TECHNICAL BULLETIN

FUJI HEAVY INDUSTRIES LTD.

NO. 200-024 DATE May 7, 2010 (SUPERSEDES NO.)

| 1. SUBJECT | : Installation of New COMM/NAV Transceiver and COMM Antenna |

Figure 2 Entire fuselage (Sheet 2)

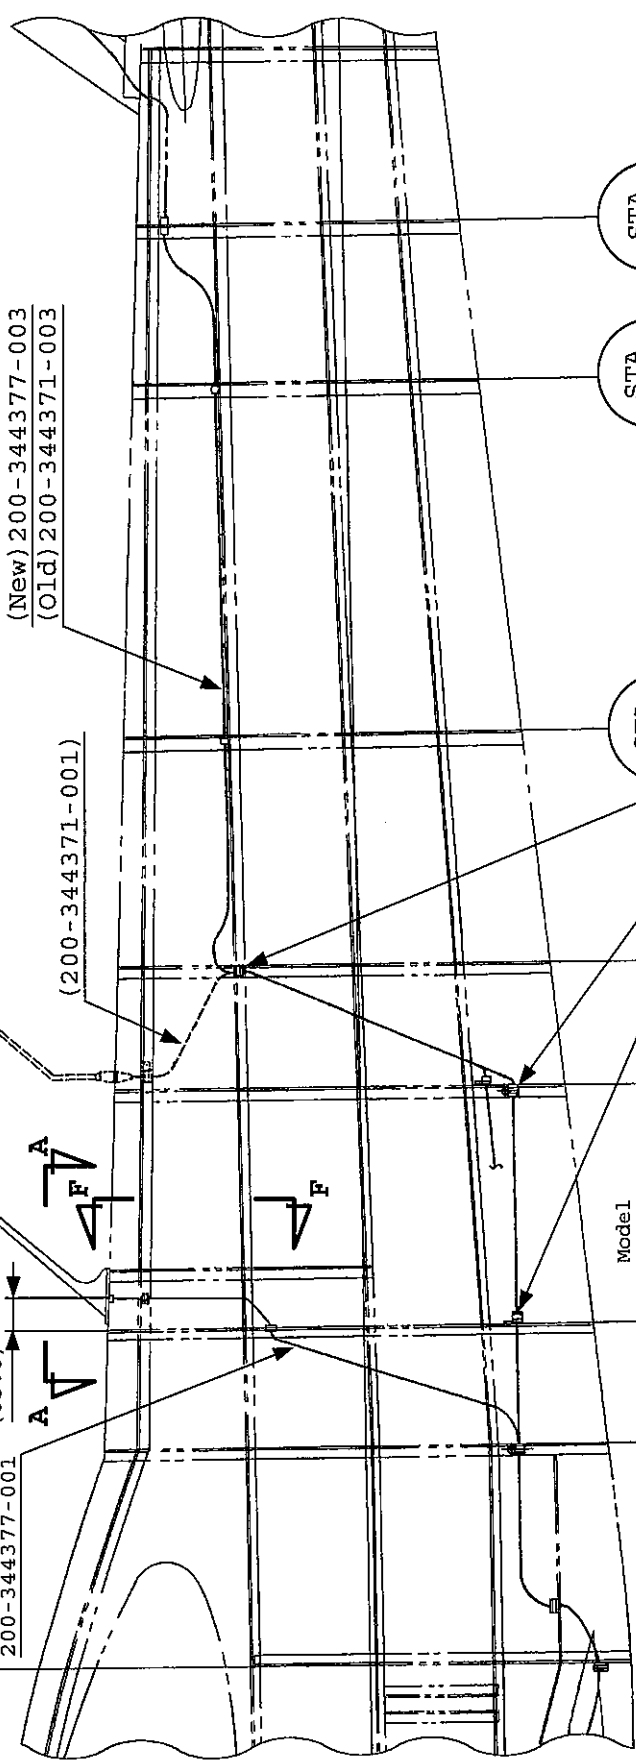
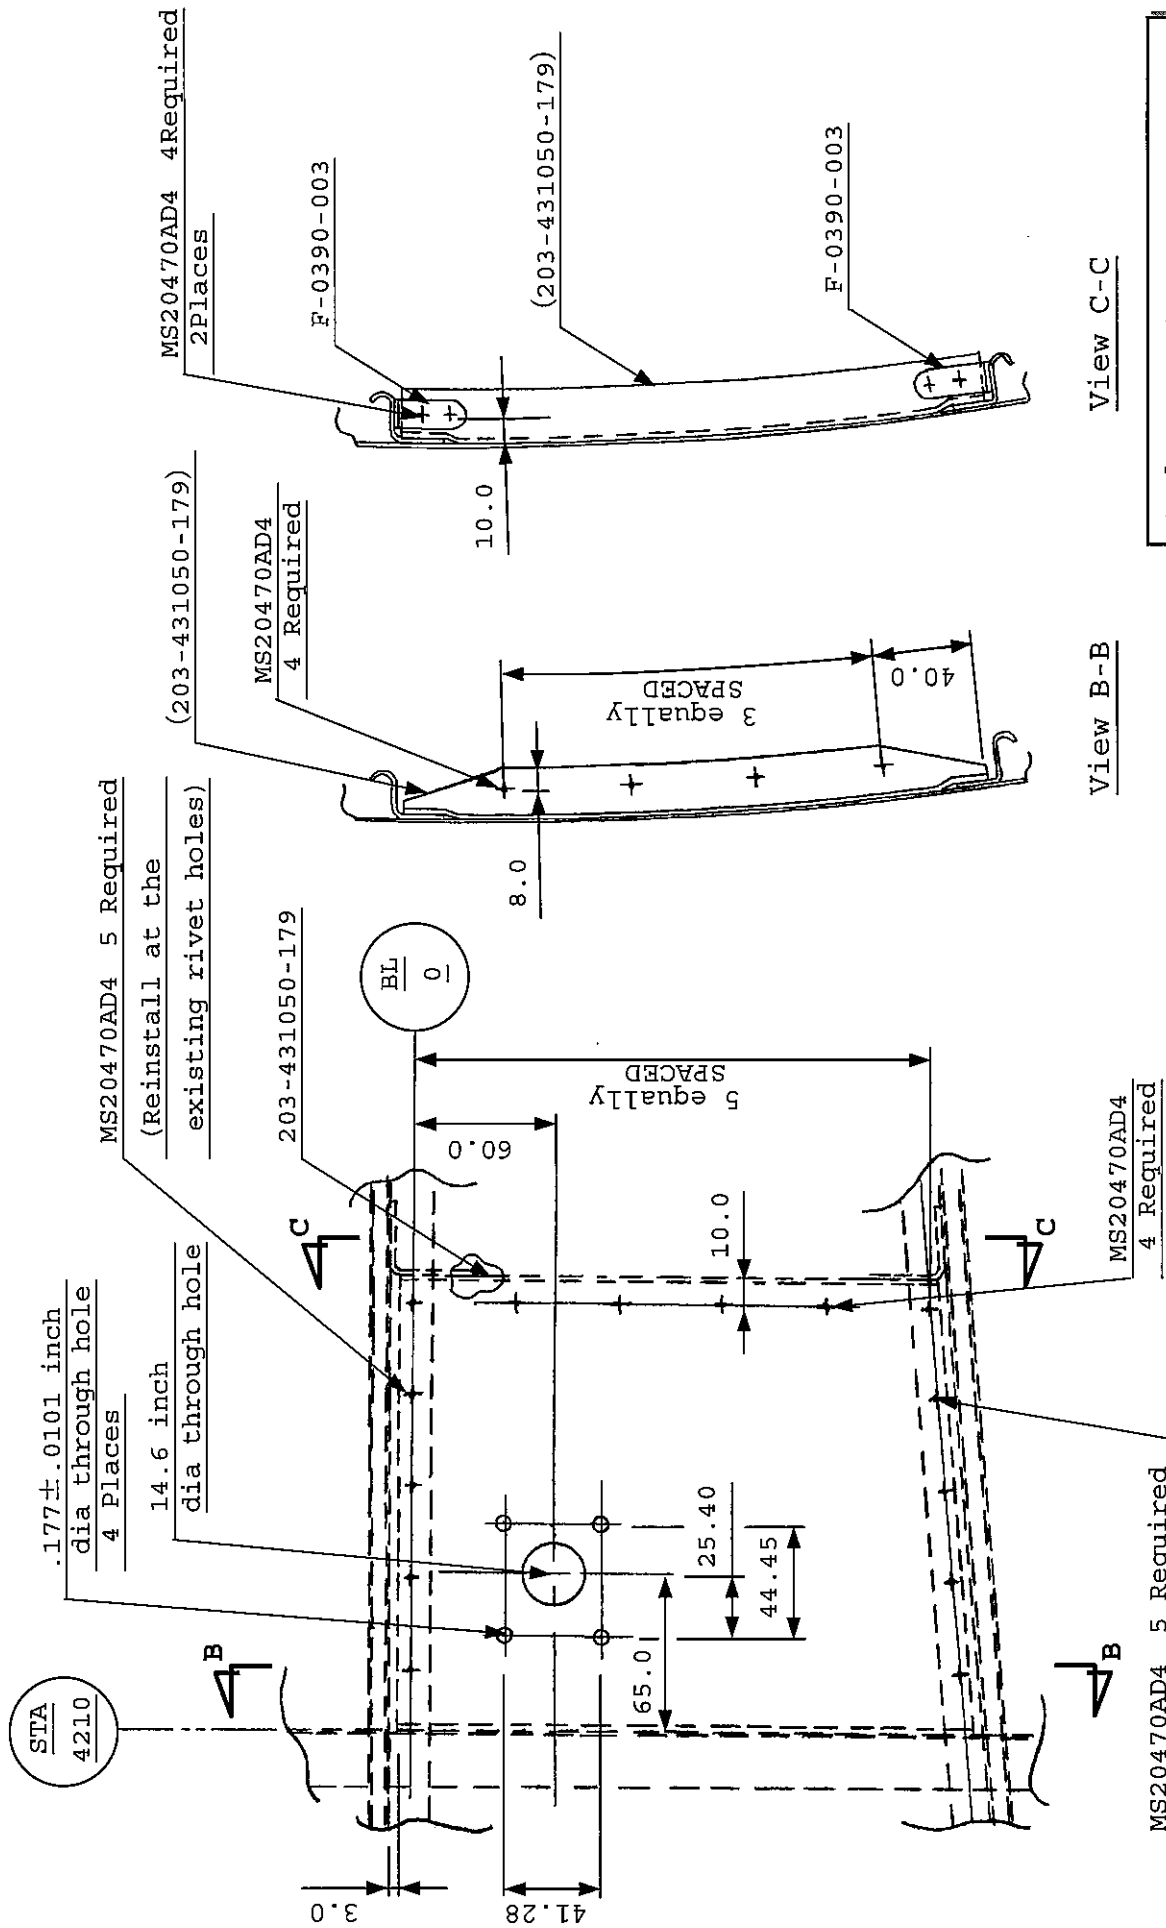
- (1) Referring to Figure 2, remove old COMM antenna (KA-24) and cable (200-344371-001). Retain clamps and clamp attaching screws for reuse, except as noted.
- (2) In order to plug old COMM antenna mount hole in fuselage skin, locally fabricate a patch plate to match the hole in accordance with Service Manual, Chapter 13, Structural Repair. Install the patch in place. When installing, apply sealant (MIL-S-8802 TYP2 CL B-2 or equivalent) to faying surface of the patch.

- (1) Install stiffener (203-431050-179) and clips (F-0390-003) as shown in Figures 2 and 3. When installing stiffener, drill new COMM antenna mount holes through skin and stiffener.
- (2) Referring to Figure 2, install new COMM antenna (CI 121). After installation of new COMM antenna, apply bead of sealant (MIL-S-8802 TYP2 CL B-2 or equivalent) around the antenna base. Blend out excessive sealant around edges.

- (1) Referring to Figure 2, remove old VOR antenna cable (200-344371-003).
- (2) Referring to Figure 7, connect P002 connector (030-00101-002) of new VOR antenna cable (200-344377-003) to connector of new COMM/NAV transceiver case.
- (3) Adjust cable length on installation, and install J004 jack (UG-291C/U).
- (4) Connect jack J004 to P004 connector as shown in Figure 2. At this time, change size of clamps which were used for old COMM antenna cable.

Figure 4 View D-D

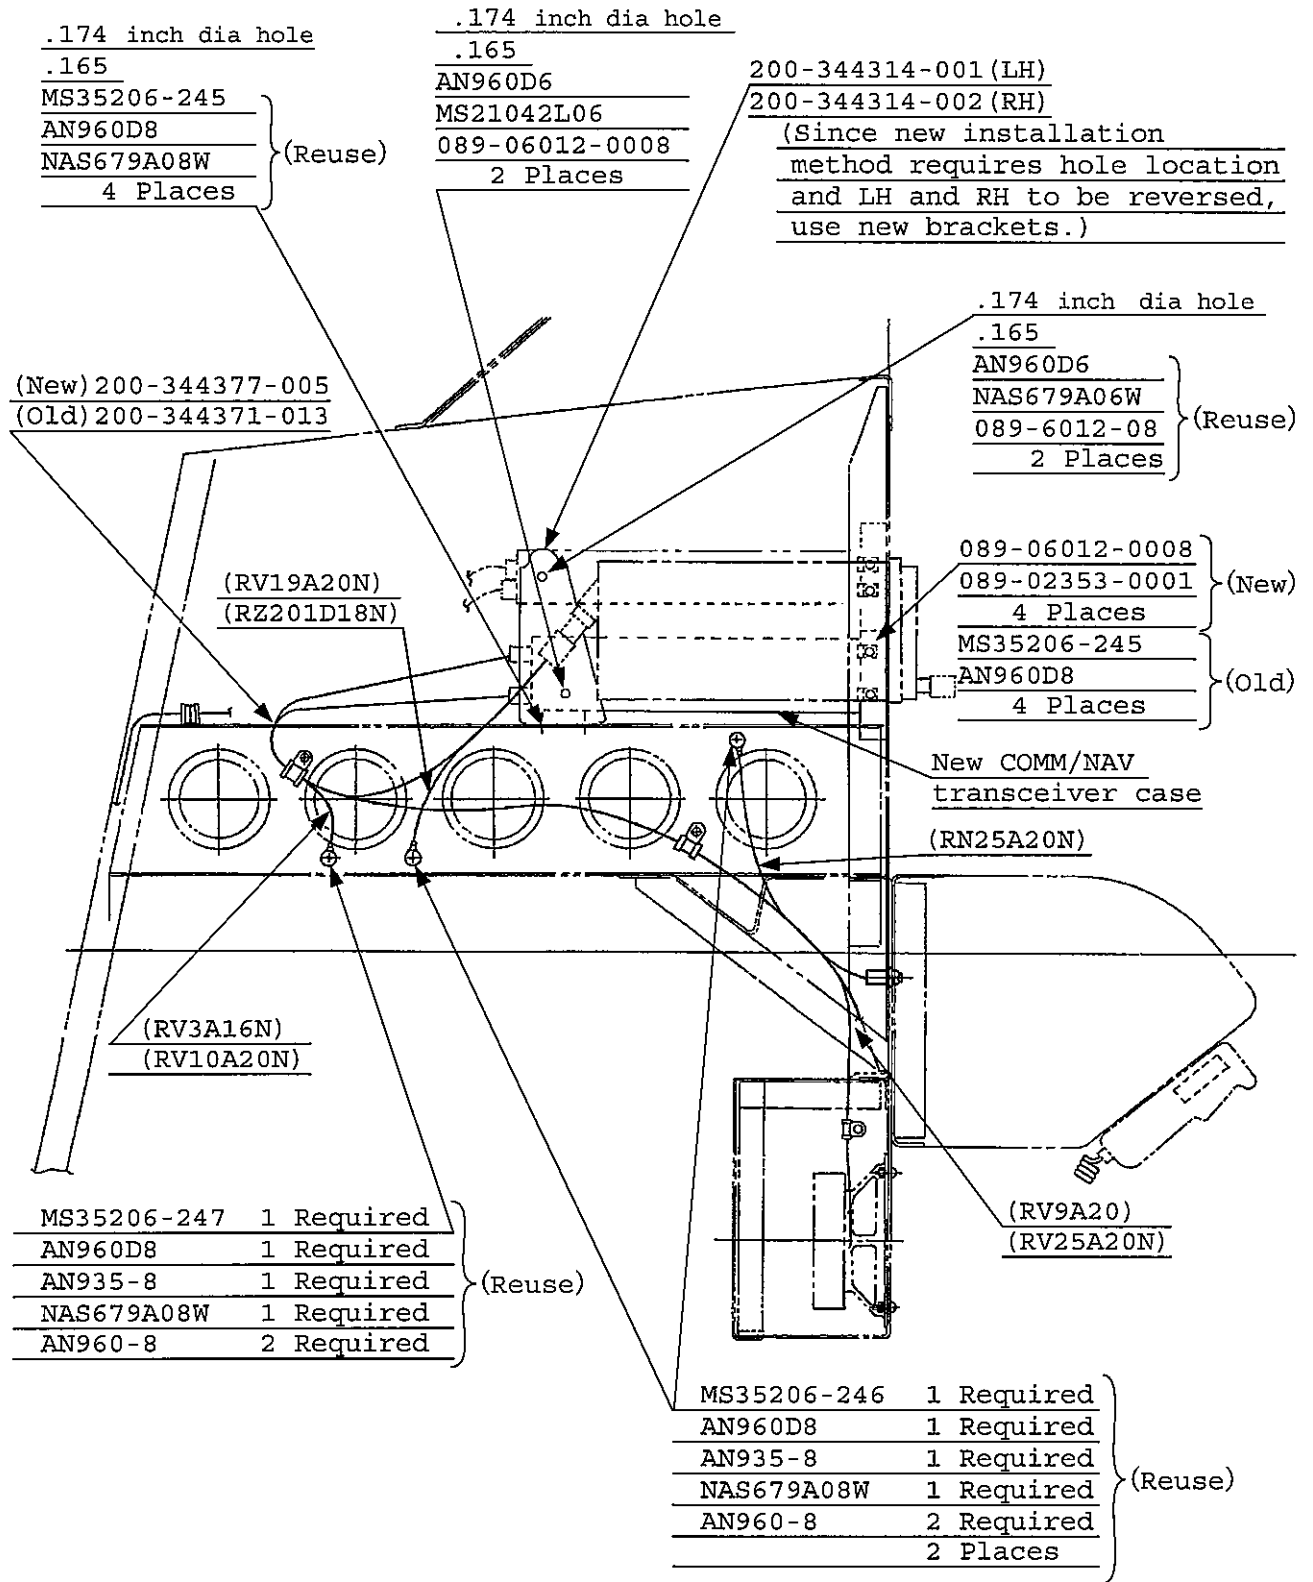
- (1) Remove old COMM/NAV transceiver (KX-175 or KX-175B), connector and case.
- (2) Remove ADF receiver (KR-87), connector and case.
- (3) Remove fwd brackets (200-344101-001) securing old COMM/NAV transceiver, and install new brackets (200-344101-007/-008) in accordance with Figure 4.
- (4) Install new COMM/NAV transceiver (KX-155) case on fwd brackets in accordance with Figure 5.
- (5) Remove existing aft brackets (200-344313-001/-002), and install new brackets (200-344313-001/-002), paying attention to installation direction, as shown in Figure 5. At this time, drill mount holes in new aft brackets to match holes in ADF receiver case and COMM/NAV transceiver case, and install new brackets in place. Also, drill holes in instrument panel frame to match new aft brackets, and secure brackets in place.

- (6) Since new and old COMM/NAV transceivers are different in size, locally fabricate and install shim plate as required to fill gap, in accordance with Figure 4.

- (1) Replace fuses for COMM and NAV from 5A to 10A in accordance with Figure 4.
- (2) Attach placard (F-0575-010) to fuse holder area to change fuse capacity symbol for COMM and NAV.

Figure 5 View E-E

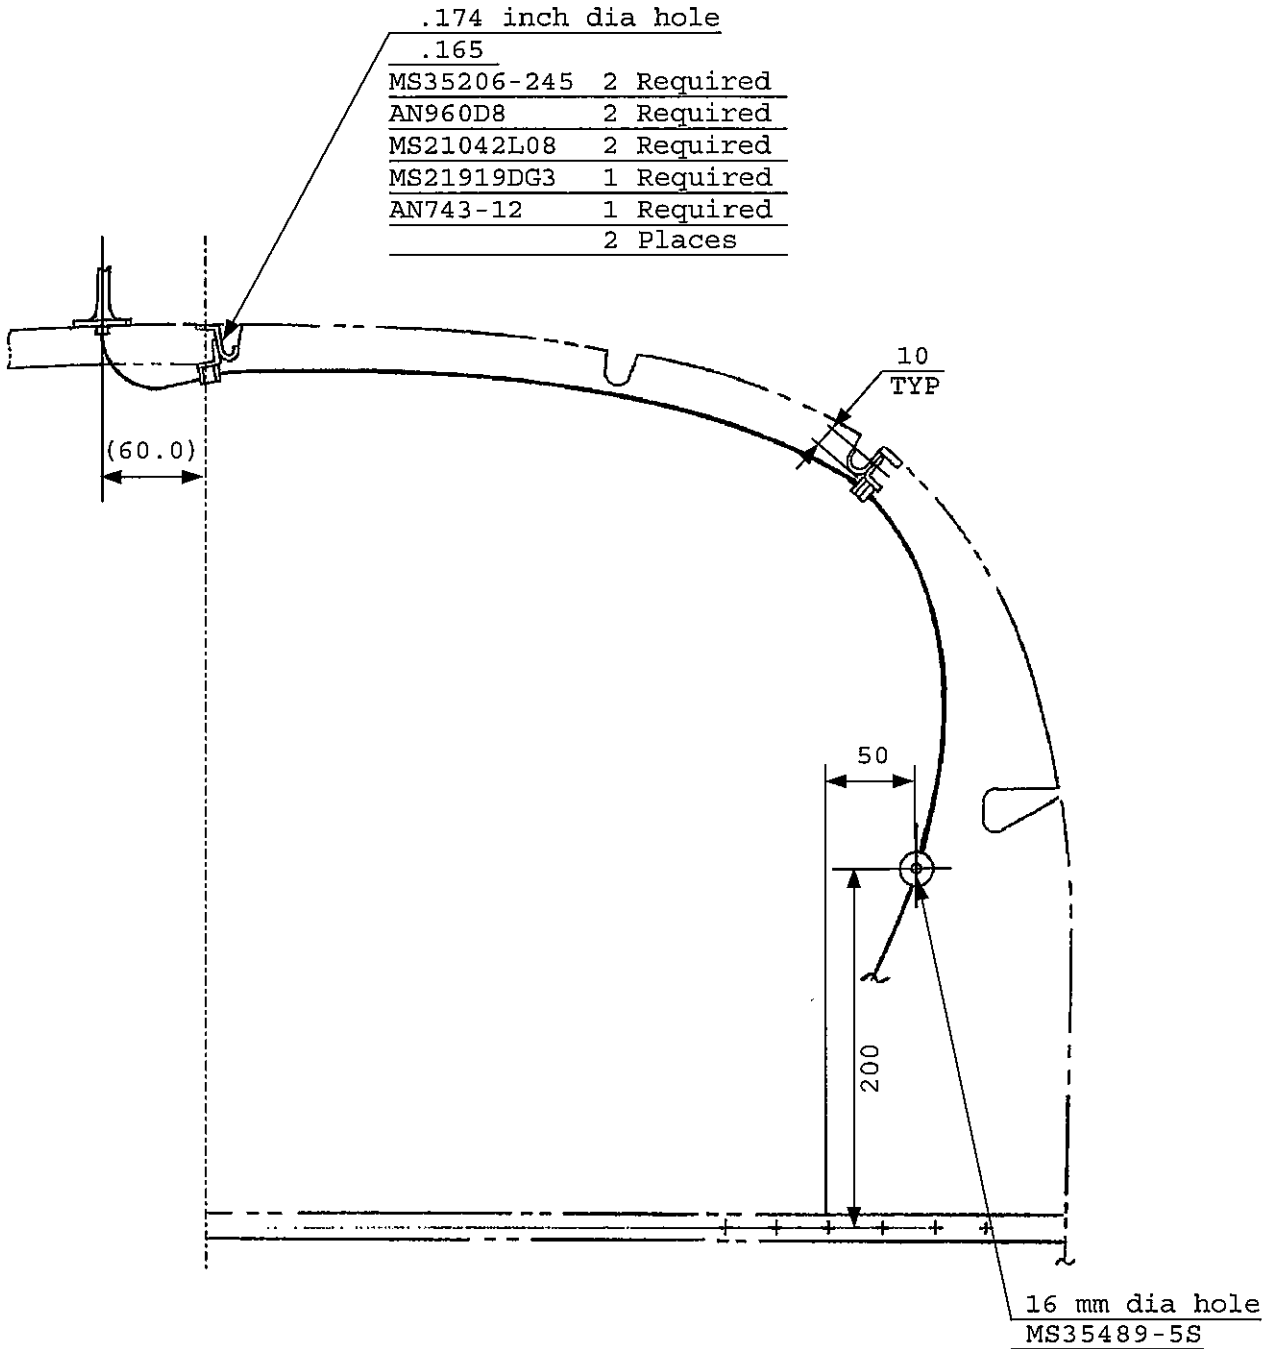
- (1) Referring to Figures 4, 5 and 7, remove old harness behind instrument panel (200-344371-013).
- (2) Referring to Figure 7, connect to new COMM/NAV transceiver P005 connector (030-01094-0059) and P007 (030-01094-0060) connector of harness behind instrument panel (200-344371-013).
